**Landscape Review Committee**  
**Community Development Center, 231 NE 5<sup>th</sup> Street**  
**July 17, 2019**  
**12:00 PM**

DATE: July 17, 2019  
TO: Landscape Review Committee Members  
FROM: Jamie Fleckenstein, Associate Planner  
SUBJECT: Landscape Plan Revision Application (L 22-02)

This is the consideration of a revision to an approved landscape plan (L 22-02) for the Dutch Bros. coffee stand at Citizen's Bank. The applicant is requesting to remove five trees from the landscape plan as they have struggled with finding a tree that will grow in this space after planting two different species of trees over the past fifteen years only to have them die and have to be removed.

**Figure 3: Proposed Landscape Plan Revision**

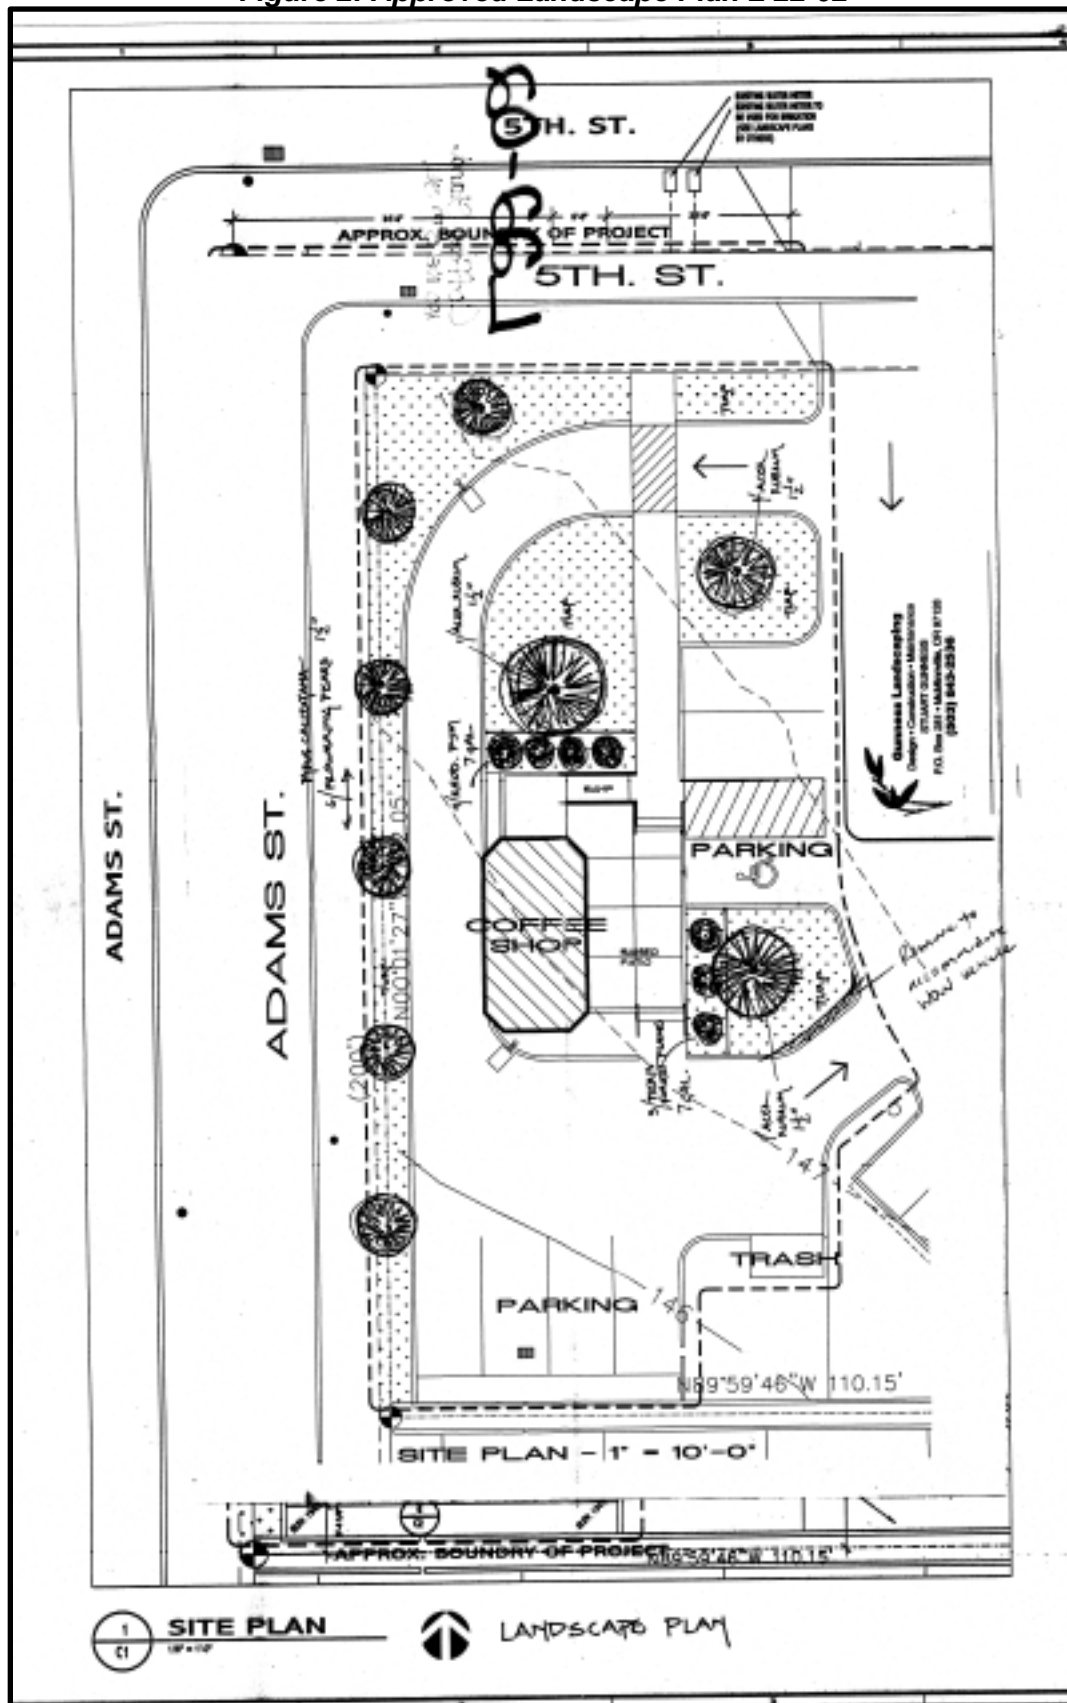
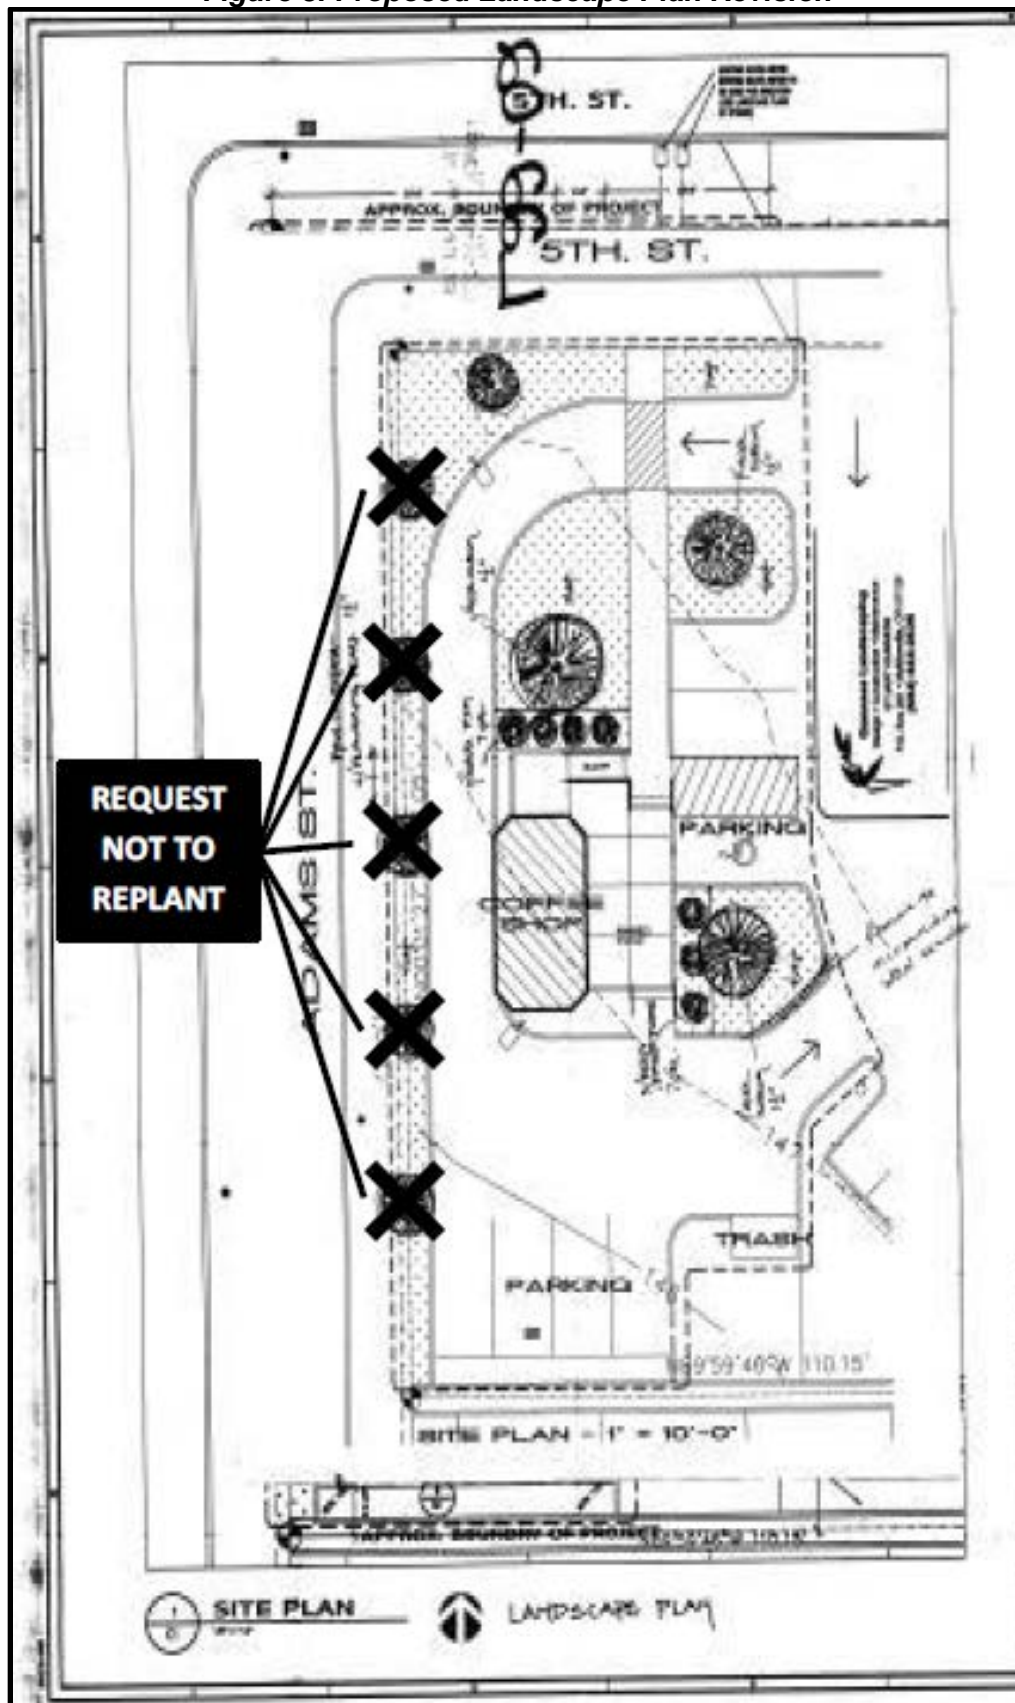
The applicant has submitted a revised plan indicating the proposed removal of five (5) trees along Adams Street along with a letter stating the reasons for the request, and letters of support from two local landscape companies, including the maintenance company for the subject property. **See Figure 3 (Proposed Landscape Plan Revision).**

The removal of the trees along Adams Street from the approved landscape plan is compatible with the commercial use of the coffee stand on the subject site. The location of the trees was between the coffee stand structure, the drive-thru lane, and the public sidewalk in a narrow planting strip. When trees were planted in that location, they blocked visibility of signage and the stand from Adams Street, a major arterial that is the source of much drive-up business. Additionally, due to the proximity of the drive-thru lane to the planting strip, the trees were often in conflict with larger vehicles driving through the coffee stand. Therefore, when the trees in question were in place, they were in conflict with the uses on the site, and the request to revise the landscape plan to remove the five (5) trees along Adams Street would not make the revised landscape plan non-compliant with this Planning Factor.

buffering purposes. The request to revise the landscape plan to remove the five (5) trees along Adams Street would not make the revised landscape plan non-compliant with this Planning Factor.

Four (4) existing trees identified on the approved landscape plan on the subject site continue to thrive on the site and will remain. No existing trees are proposed for physical removal as part of the landscape plan revision request. The request to revise the landscape plan to remove the five (5) trees along Adams Street would not make the revised landscape plan non-compliant with this Planning Factor.

Staff **RECOMMENDS APPROVAL** of the landscape plan revision.

***Figure 3: Applicant's Site Plan***

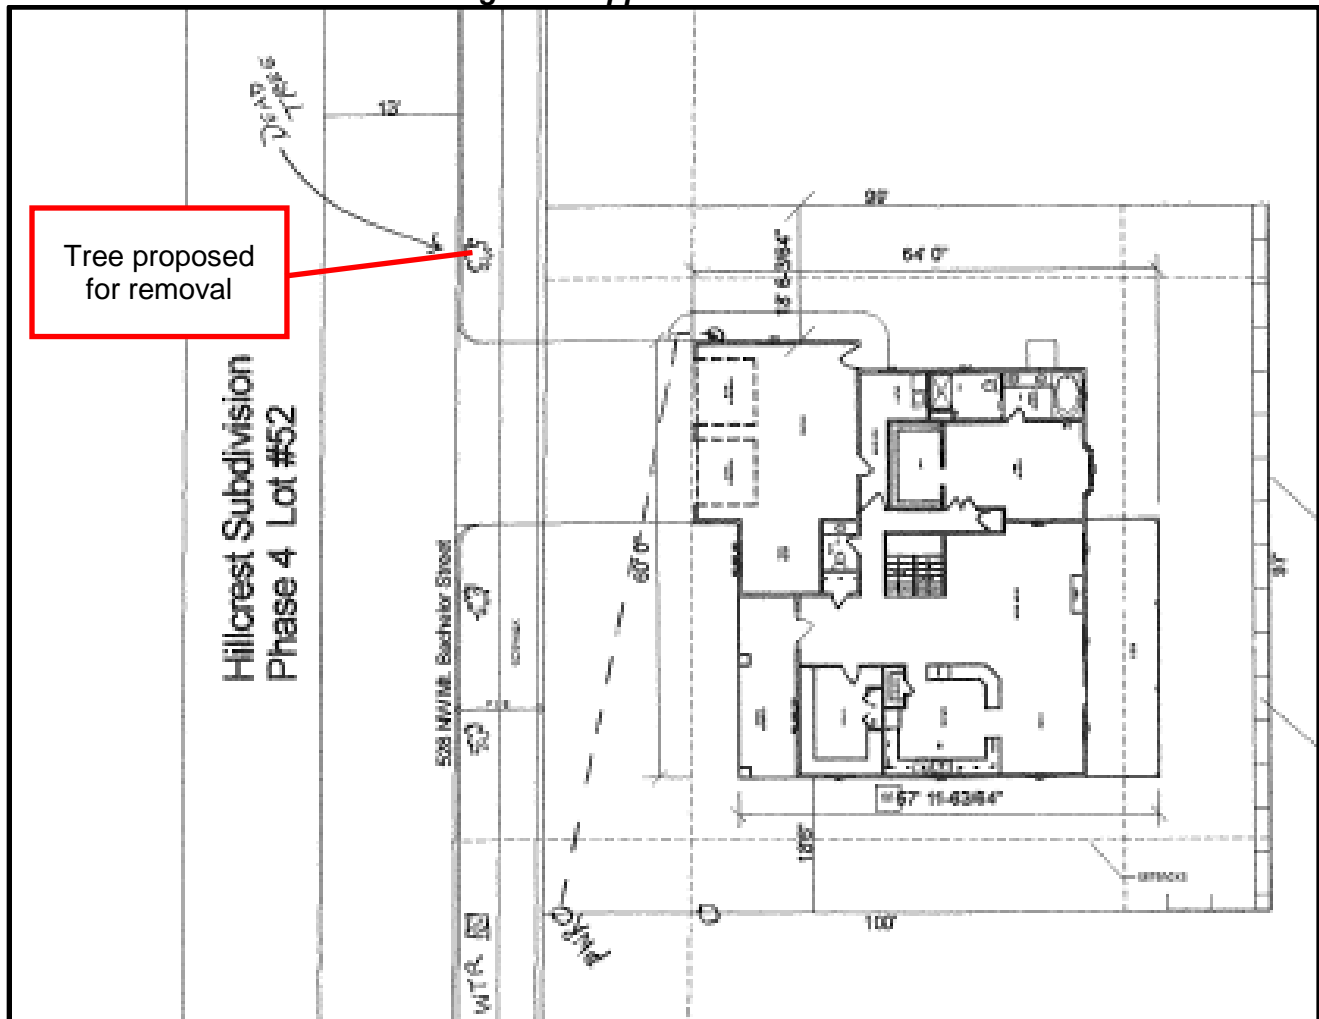
The applicant has requested the removal of one (1) street tree because the tree is dead. The subject tree is located in the NW Mt. Bachelor right-of-way, north of the driveway and south of a community mailbox. **See Figure 3 (Applicant's Site Plan) & Figure 4 (Planter Strip).** The tree is a red maple variety (*Acer rubrum* var.) that measures approximately five (5) inches DBH (diameter at breast height) and is located in a five (5) foot wide planter strip, approximately eight (8) feet north of the driveway approach. The tree appears to be in dead. **See Figures 5 & 6 (Subject Tree Condition).** The tree is not showing new leaf or twig growth and no vigor in comparison to the two (2) existing red maple trees in the adjacent planter strip on the south side of the driveway approach. **See Figure 7 (Adjacent Street Tree Condition).**

***Figure 3: Applicant's Site Plan***

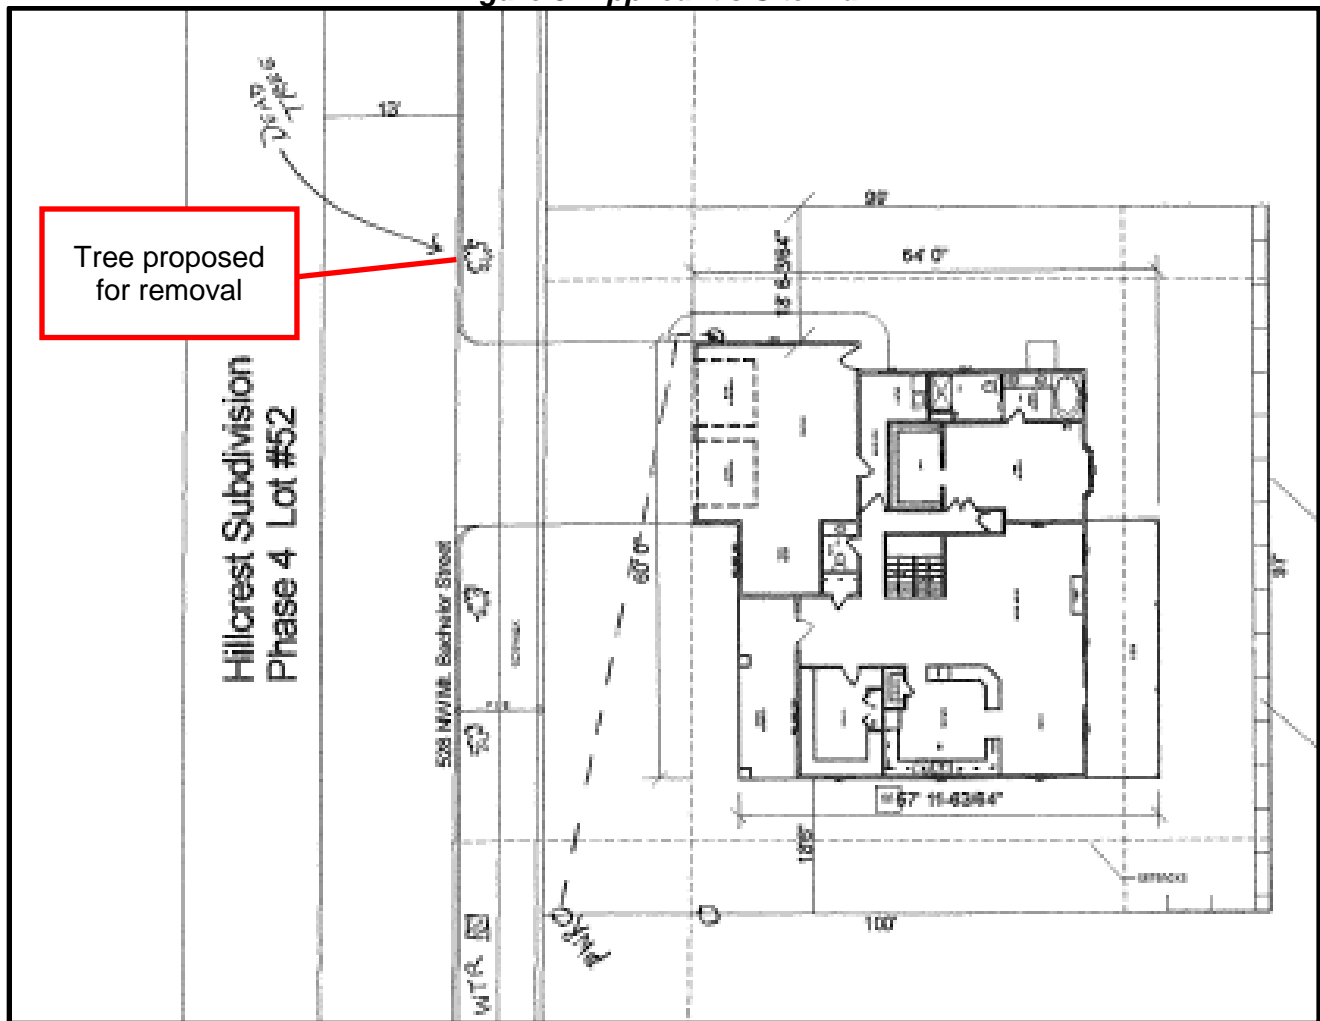
The applicant has requested the removal of one (1) street tree because the tree is dead. The subject tree is located in the NW Mt. Bachelor right-of-way, north of the driveway and south of a community mailbox. **See Figure 3 (Applicant's Site Plan) & Figure 4 (Planter Strip).** The tree is a red maple variety (*Acer rubrum* var.) that measures approximately five (5) inches DBH (diameter at breast height) and is located in a five (5) foot wide planter strip, approximately eight (8) feet north of the driveway approach. The tree appears to be in dead. **See Figures 5 & 6 (Subject Tree Condition).** The tree is not showing new leaf or twig growth and no vigor in comparison to the two (2) existing red maple trees in the adjacent planter strip on the south side of the driveway approach. **See Figure 7 (Adjacent Street Tree Condition).**

**FINDING: SATISFIED WITH CONDITION #4.** The subject street tree is located in a 5 foot wide planting strip between a driveway approach and a community mailbox pad. The existing tree is located approximately eight (8) feet from the driveway approach and approximately five (5) feet from the mailbox pad. Given the minimum five (5) foot spacing standard from private driveways, there is sufficient space in the planter strip to accommodate a replacement tree.

**CONDITION FOR FINDING:** That one (1) replacement street tree be planted in the NW Mt. Bachelor Street right-of-way planter strip. The tree shall a recommended medium street tree from the McMinnville Street Tree List, or other species/variety approved by the McMinnville Landscape Review Committee.

**Figure 2: Applicant's Proposed Site Plan****Attachments:**

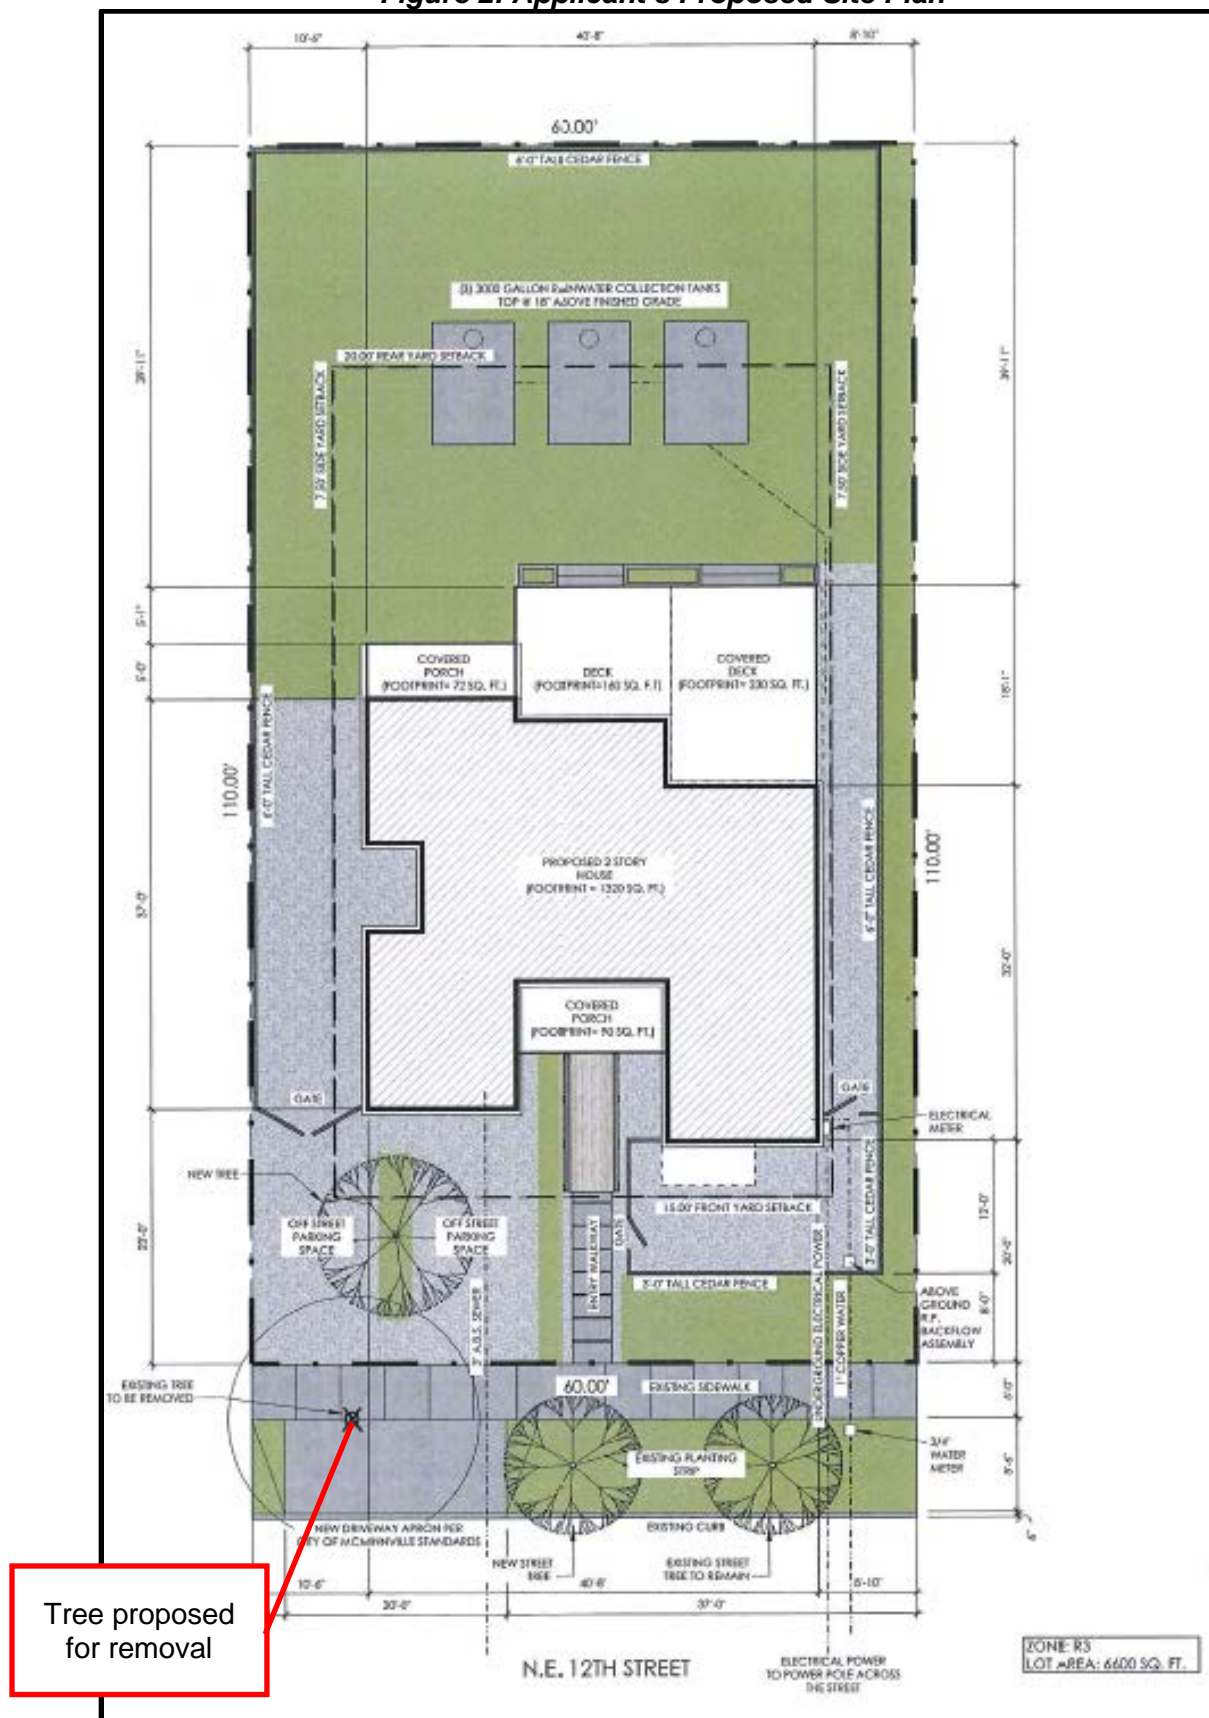
The applicant has requested the removal of one (1) street tree because of conflict with public improvements. The subject street tree is adjacent to the property at 620 NE 12<sup>th</sup> Street. The site, along with the adjacent property on the corner of NE 12<sup>th</sup> Street and NE Ford Street, until recently had been considered to be one tax lot by the Yamhill County Tax Assessor. The property owner was able to provide evidence that the lots were in fact separate historic lots, and they are now considered two separate legal lots. The larger previously combined lot had driveway access from NE Ford Street. The property owner is now proposing to build a new single-family residence at 620 NE 12<sup>th</sup> Street. Part of the development proposal is locating a new driveway curb-cut to access the property from NE 12<sup>th</sup> Street, where no curb-cut exists now. **See Figure 2 (Applicant's Proposed Site Plan).**

The proposed development plan (**See Figure 2 (Applicant's Proposed Site Plan)**) indicates that a replacement street tree is proposed for the planter strip adjacent to the new driveway. Additionally, a second tree is proposed on private property breaking up the off-street parking spaces for the new residence. Given the sufficient space in the planter strip between the proposed driveway approach and the adjacent street tree, and spacing from public improvements and utilities, staff is recommending a replacement tree be required. No approved street tree plan is on file with the Planning Department for this subdivision. A tree from the McMinnville Street Tree List - Recommended Medium Tree Species, or other species/variety approved by the Landscape Review Committee, would be appropriate for a replacement tree, and consistent with other similar sized street trees along NE 12th Street.
